# Access Compliance Report

## Public Rights-of-Way

### (Curb Ramps)

Intersection ID: N/A	Main Street: NEW_FASHION_WY	Cross Street: N/A	Location: NW
ADA ID: 3CE908D7A460	Ramp Type: Perp	Initial Pass/Fail: Fail	Overall Compliance: No
Severity Score: 33.75			
Codes/Mitigation Info/Possible Solution		Field Measurements/Component Compliance

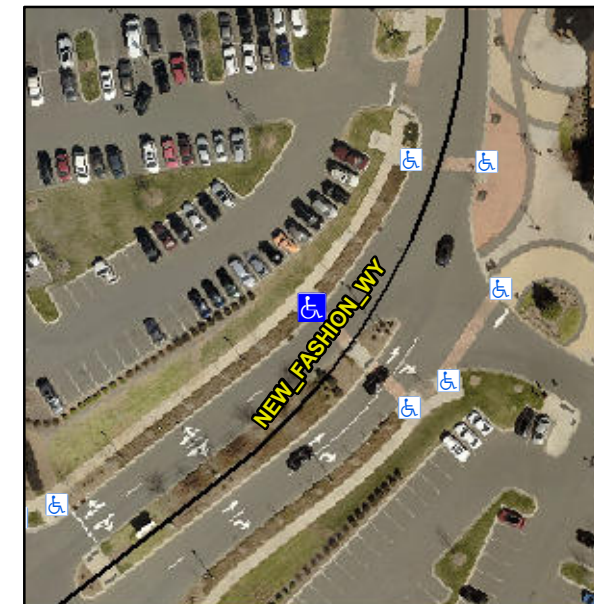
**R304.5.1, R304.5.3**

Compliance	Description	Data	Compliance	Description	Data
N/A	Ramp Length (in)	97.0	Yes	Ramp Slope (%)	6.8
No	Ramp Width (in)	45.0	No	Ramp XSlope (%)	7.7
N/A	Flare Type LT	N/A	N/A	Flare Type RT	N/A
N/A	Flare Slope LT (%)	N/A	N/A	Flare Slope RT (%)	N/A
N/A	Flare Traversable LT?	N/A	N/A	Flare Traversable RT?	N/A
N/A	Landing Length (in)	N/A	N/A	DWS Provided?	N/A
N/A	Landing Width (in)	N/A	N/A	DWS Contrast?	N/A
N/A	Landing Slope (%)	N/A	N/A	DWS Length (in)	N/A
N/A	Landing X Slope (%)	N/A	N/A	DWS Full Width?	N/A
N/A	Landing Curb? (Y/N)	N/A	N/A	DWS Offset (in)	N/A
N/A	Shared Landing?	N/A			
N/A	Gutter Ponding?	N/A	N/A	Gutter Slope (%)	N/A
N/A	Gutter Lip Ht (in)	N/A	N/A	Gutter X Slope (%)	N/A
N/A	Painted X Walk1?	Yes	N/A	Painted X Walk2?	N/A
	X Walk 1 Direction	To SE		X Walk 2 Direction	N/A
N/A	X Walk 1 Width (in)	80.0	N/A	X Walk 2 Width (in)	N/A
	X Walk 1 Slope (%)	3.1		X Walk 2 Slope (%)	N/A
	X Walk 1 X Slope (%)	8.1		X Walk 2 X Slope (%)	N/A

**Remove & Replace Entire Ramp.**
